RE: Open Dump

Re: Chatham or Roaring Gap Open Dump

In reviewing our records we find that the revised plans for the new solid waste disposal site proposed to be operated by the Town of Sparta have not been submitted as discussed on site several months ago. As you recall, the revised plan centered around a dyke and ramp type disposal operation as apposed to the trenching plan that had been submitted for approval.

The required information for the proposed operational plan for the site off SR 1171 has been reviewed. Phase I of the plan is hereby approved for operations meeting the requirements of the State Board of Health "Rules and Regulations Providing Standards for Solid Waste Disposal."

Cross Sections for Phase I - Trenching Plan

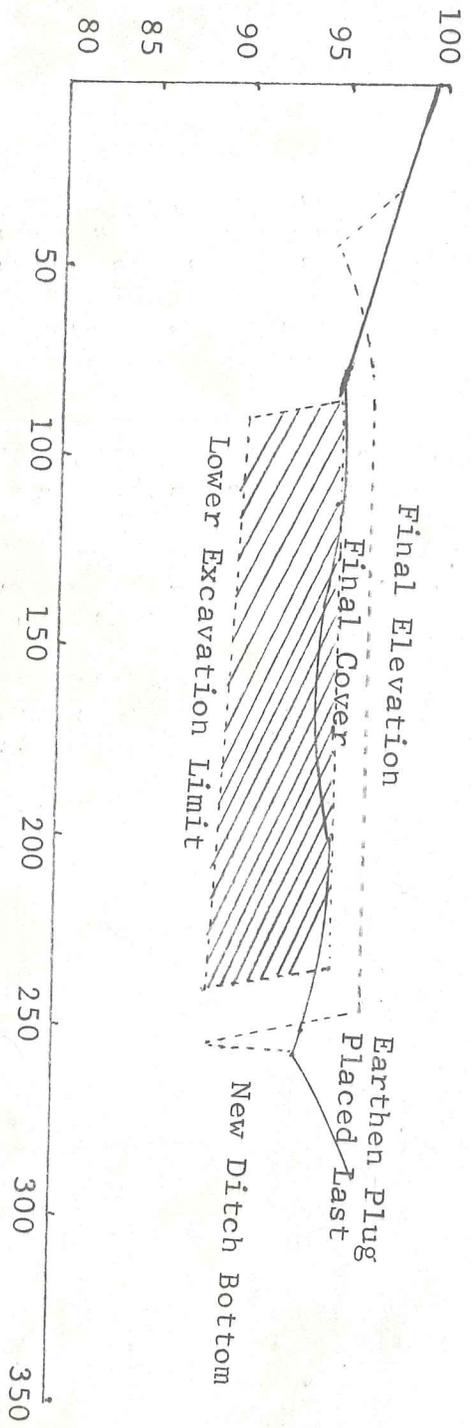
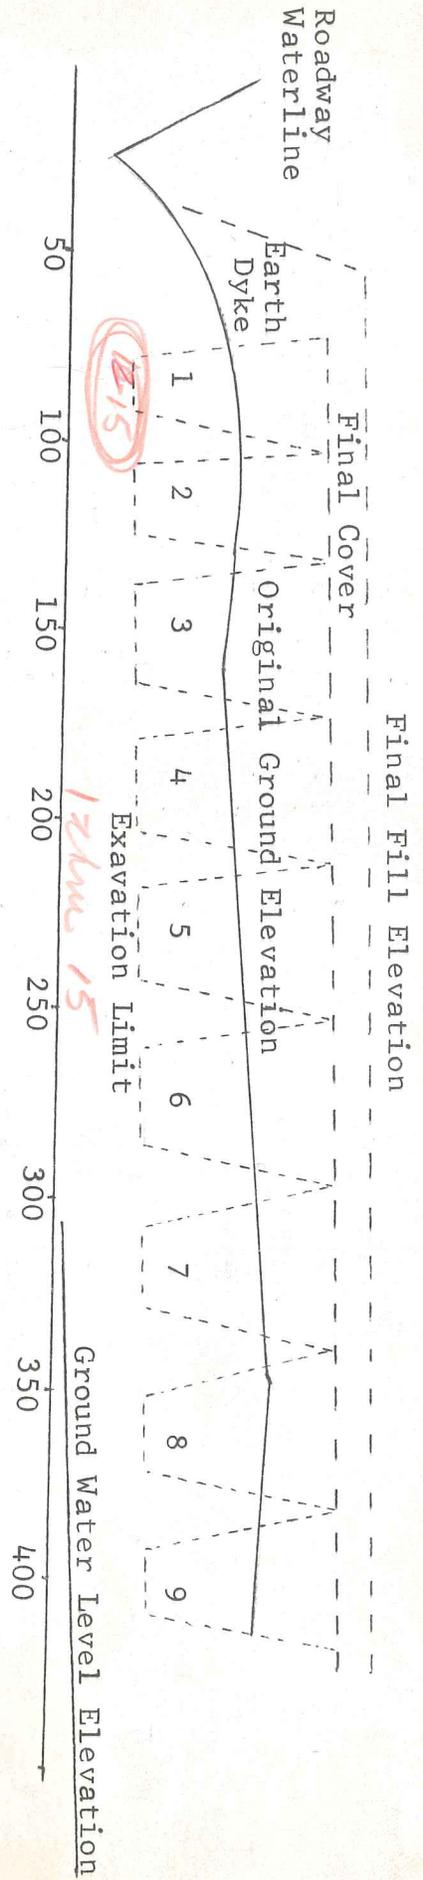
- a. Future work phases should be laid out to include open ditch drainage from the spring area. However, if the need dictates filling in this area, then piping with a backfill of six feet compacted earth will be required.
- b. Trench bottom width should be held to 12 to 15 feet to give you a better balance of waste to earth (at least 4 to 1). Excess excavated earth can be used to build up the low sides of the property.
- c. Prior to commencement of future work phases, submit similar operational plans in accordance with the solid waste regulations.
